Sub: Technical Audit Report Nos. RDSO/2025/EL/TAR/0036 Rev. '0' dated 05.03.2025 on Traction motor (6FRA6068) maintenance at Electric Loco Shed, Royapuram (SR)

# Technical Audit Report of Electric Loco Shed, Gomoh for maintenance of three phase locomotive Traction Motors (TM)type-6FRA6068

Report No.: RDSO/2025/EL/TAR/0037 Rev '0'

Free RC Measurement Bearing Assly Room

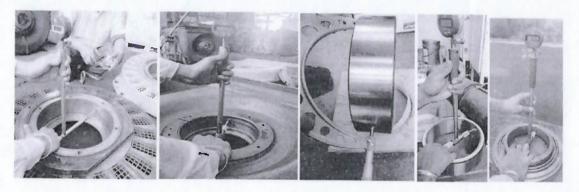
- (i) The bearings DE & NDE of traction motor at shop floor were kept properly in a separate bearing assembly room. However, the some components of failed TM and new components are also kept in same room. There is no facility for temperature/ humidity control, moreover Induction Heater is also installed in same room.
- (ii) In Main Store ward of Shed, bearings were kept packed in wooden boxes properly stacked. The main store of shed has not provided with temperature/humidity control facility. Practice of FIFO (First in First Out) was being followed.
- (iii) Free radial clearance of all bearing were checked & notedbefore use of particular bearing.

- (i) The bearing assembly area should be neat &clean and dust free. The components of failed TM and new components may be kept separately at suitable location.
- (ii) Induction Heater may be shifted to another suitable location from bearing assembly room.

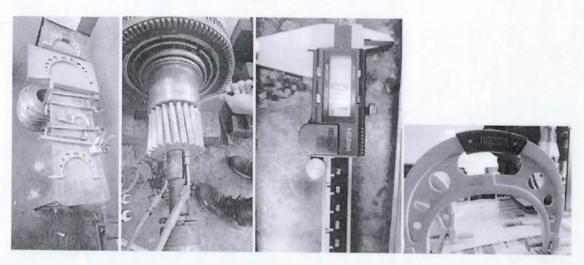
- (iv) In shop floor, measurements of assembly components were being carried out by using bore dial gauge having least count of 1 micron for ID as per SMI-318 and outside micrometres having least count of 10 micron for OD.
- (v) Snap gauges were available (1 set in shop floor & 1 set at tool room) but not being used for measurement of shaft OD as master for calibration is not available at shed and same was indented. Different dial snap Gauges/ bore dial gauges are calibrated.

Use of Dial snap gauge with least count of 1 micron to be done for measuring OD of shaft, outer racer at various location and use of bore gauge with least count of 1 micron for measurement of ID of inner racer, end frame (NDE/DE) etc as per SMI 314/318.

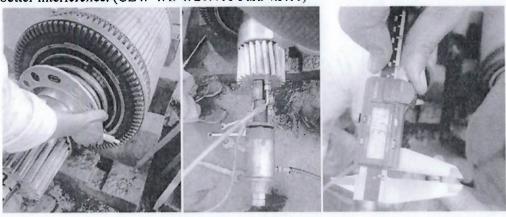
- (i) In shed shop floor, staff is aware for proper use of Ring Gauge provided by M/s ABB. They are checking taperness of Pinion shaft using ring gauge as well as measuring distance between Pinion teeth face and ring Gauge face. They have good practice to measure Pinion shaft taperness in advance for all new pinions available in stock when staff is free.
- (ii) The shed has discontinued the practice of colour matching of pinion with shaft taper as prescribed in SMI-278. Shed has informed that during blue matching they always got 95% or more contact area between rotor shaft and pinion shaft.
- (iii) The practice for checking shaft taperness using plug gauge as per RDSO drawing no SKEL-5032 alt-0 is also not done as prescribed in SMI-278 and check sheet circulated by RDSO on dated 2-12-2024

- 1) Shed may please continue the practice of colour matching of pinion with shaft taperness as per SMI-0278.
- Shed may please continue the practice for checking shaft taperness using plug gauge as per RDSO drawing no SKEL-5032 alt-0 as per in SMI-278 and check sheet circulated by RDSO on dated 2-12-2024

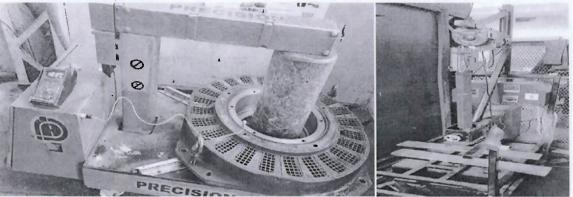
(i) Shop Floor of TM assembly area is constraint all cleaning work, dismantling & assembly is carrying out at same place. Therefore shop floor is sticky and dirty. There is no adequate space to perform separate activity at separate area. Assembled motor (ready to move), failed motors, rotors, new and released components are kept at same places.

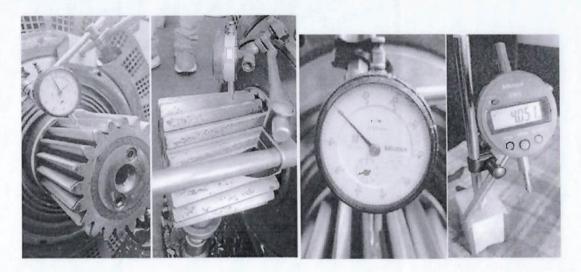
- (xi) TM assembly of TM, light run test was carried out 30 minutes in one direction only at 264V approx. During test, temperature is monitored. Shed has very old auto transformer (for DC motor testing) for performing this test. With this drive amount of current& RPM can not be monitored moreover tachometer is not available in TM section. TM section is not measuring noise & vibrations as old equipment is out of order and purchase of new SPM is under process. However, VVF Drive is available for wheeler test which is being conducted by TM Section.

- (i) Shed is advised to procure VVF Drive for light run testing at TM section.
- (ii) Shed may procure digital grease gun having the display of delivered quantity of grease to avoid the counting of stroke.
- (iii) Shed is recommended to carry out light run test in both direction for 30-30 minutes and monitor temperature, noise and vibrations.

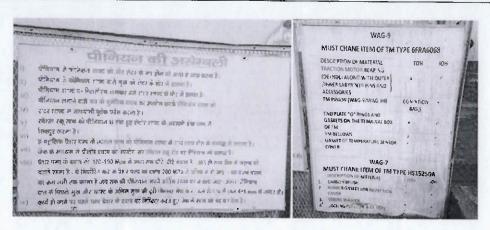
(i) Different display board regarding pinion assembly of Traction motor assembly and must change items during TOH/IOH are fixed at shopfloor locations however the location is not proper with respect to height.

**Recommendation:** Shed is advised to hang one more board indicating the dimensions of various critical bearing as well as assembly components along with their interference between mating surface.
